From: Scala, Mary Joy
Sent: Monday, February 29, 2016 3:09 PM
To: Wolf, Fred
Cc: Diamond Theo
Subject: RE: Light House

From: Fred Wolf [mailto:fw@wolfackerman.com]
Sent: Monday, February 29, 2016 12:24 PM
To: Scala, Mary Joy
Cc: Diamond Theo
Subject: Re: Light House

From: Fred Wolf [<mailto:fw@wolfackerman.com>]
Sent: Wednesday, November 04, 2015 10:21 AM
To: Scala, Mary Joy
Subject: Light House

ORIGINAL ELEVATION

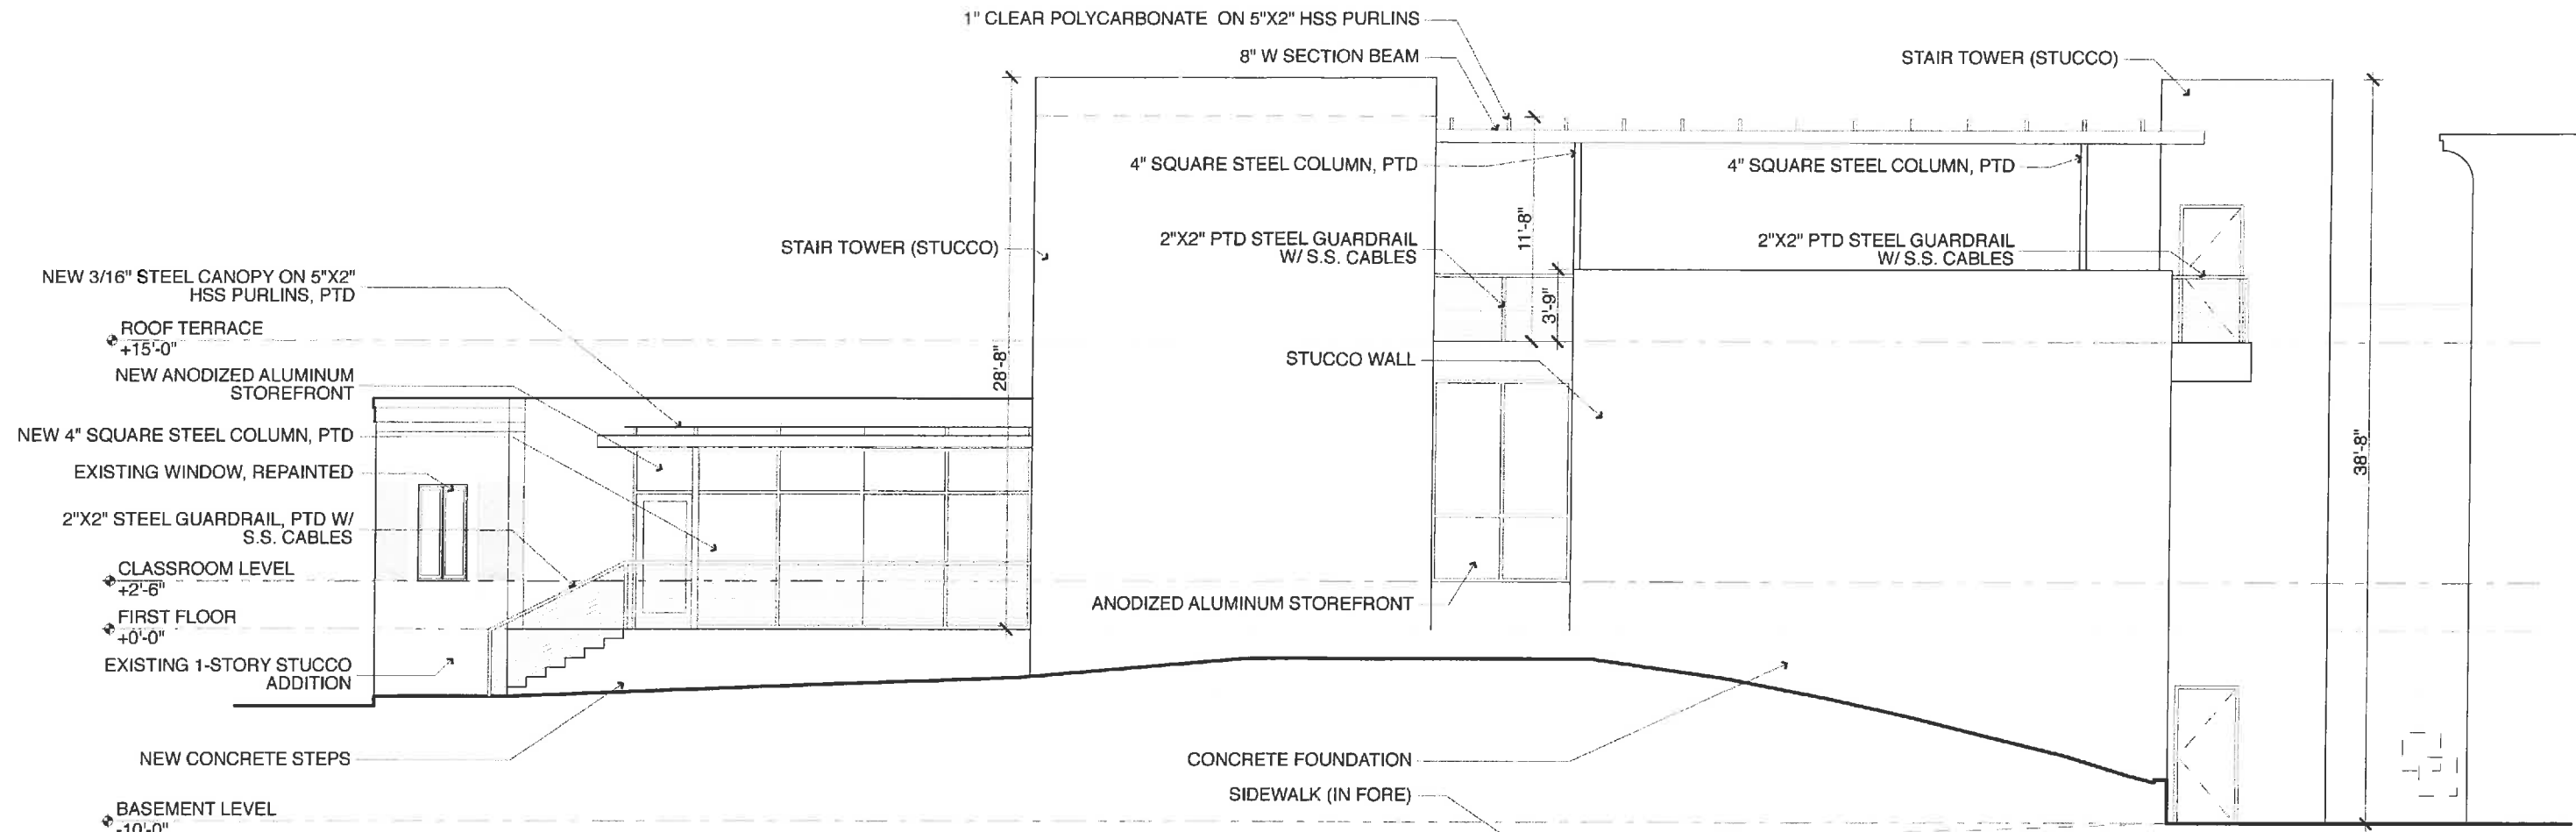
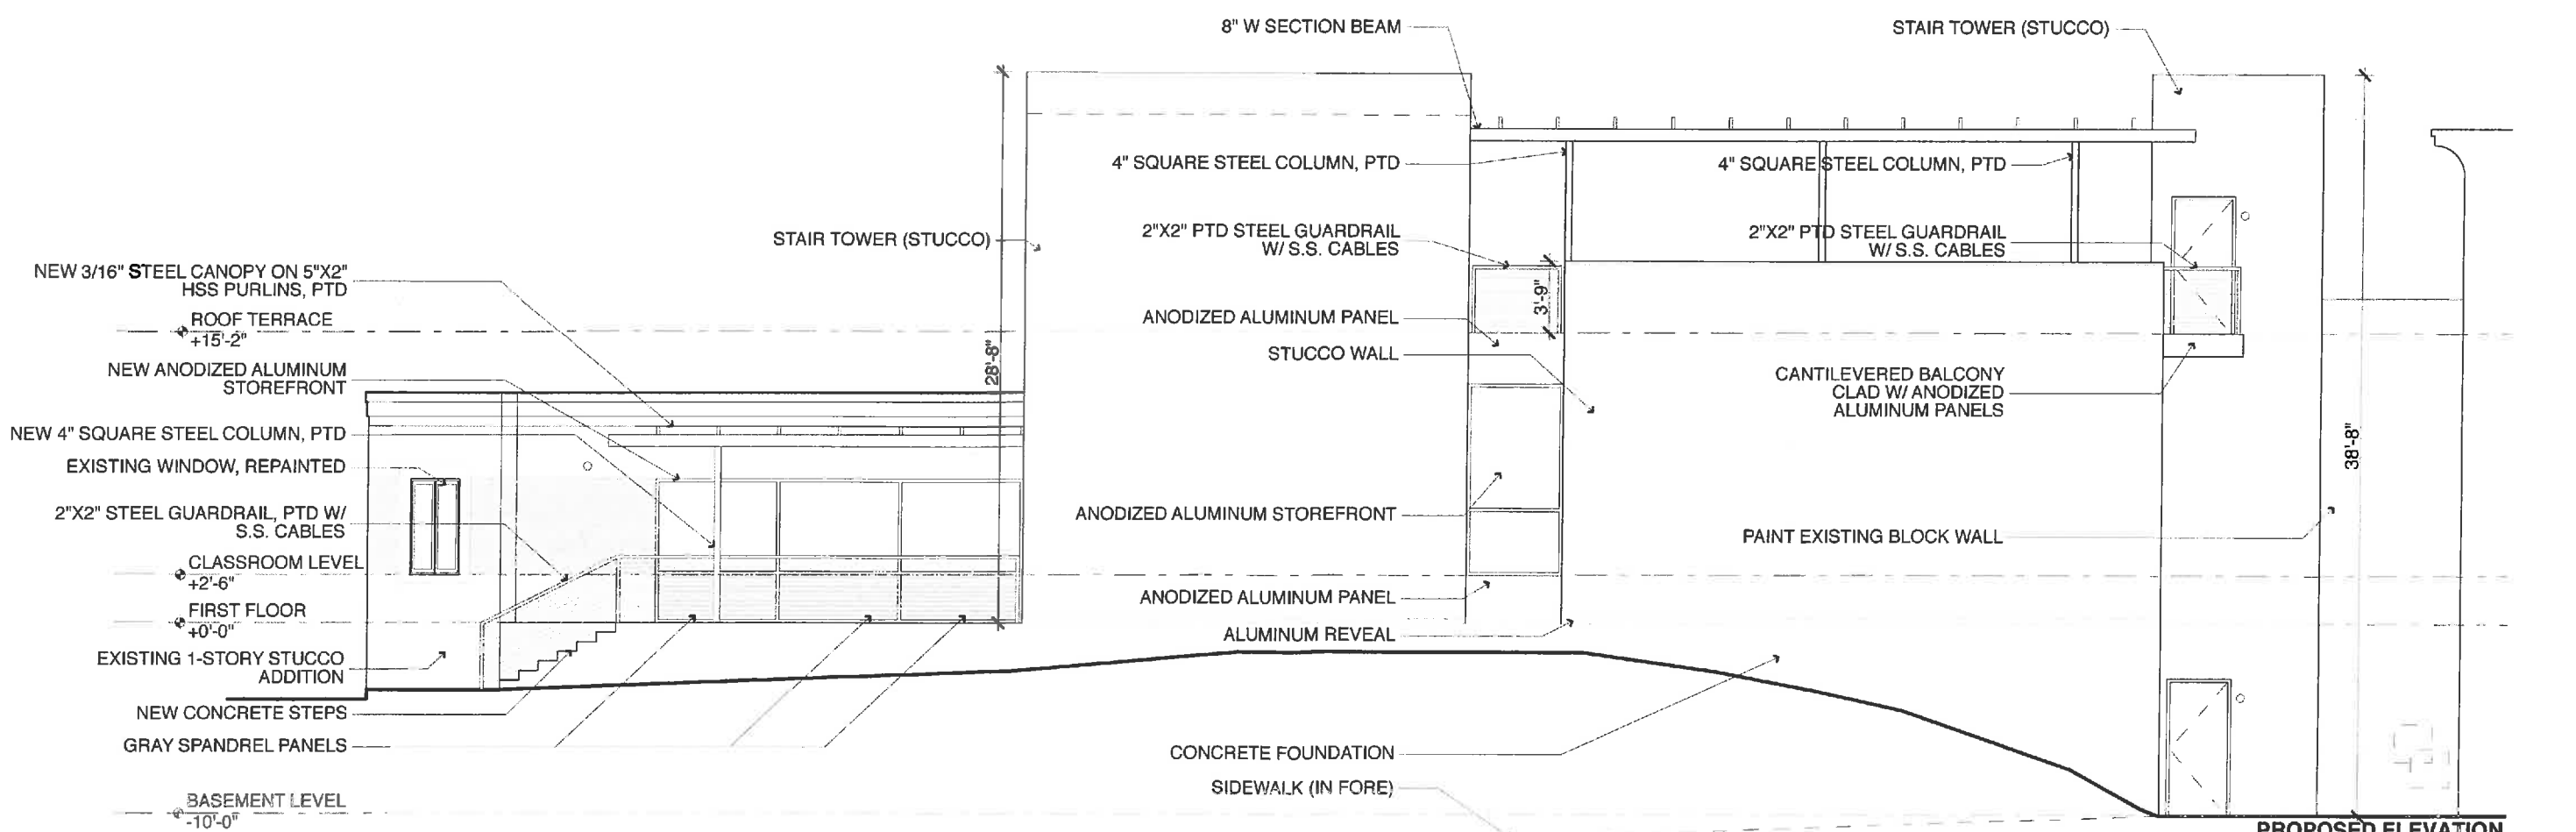
On the first drawing (West Elevation) the storefront beneath new steel canopy changed in number of glass panels, that doors was eliminated and the lower panels below desk height in that office will be spandrel glass. The window between the stucco walls was made narrower, a steel column had to be added by the structural engineer at the roof and we have removed the clear roof covering over the purlins for now. The sheet included original elevations (as approved previously) and newly proposed with these changes.

On the second drawing (South Elevation) the solid door down at the sidewalk level has changed to glass and has a transom above it just as described in the emails below.

I did want to tell you that we want to propose two very minor revisions to the design that I'd like to see if you can approve. One is that we want to make the window on the west elevation narrower by 1/2 its dimension. And the second is that we want to turn the exterior door to the lower level studio to a full lite glass door with a glass transom panel above it to provide some light in that room.

The changes are approved as submitted.

I can approve those changes administratively. You may proceed with site plan approval and building permit.
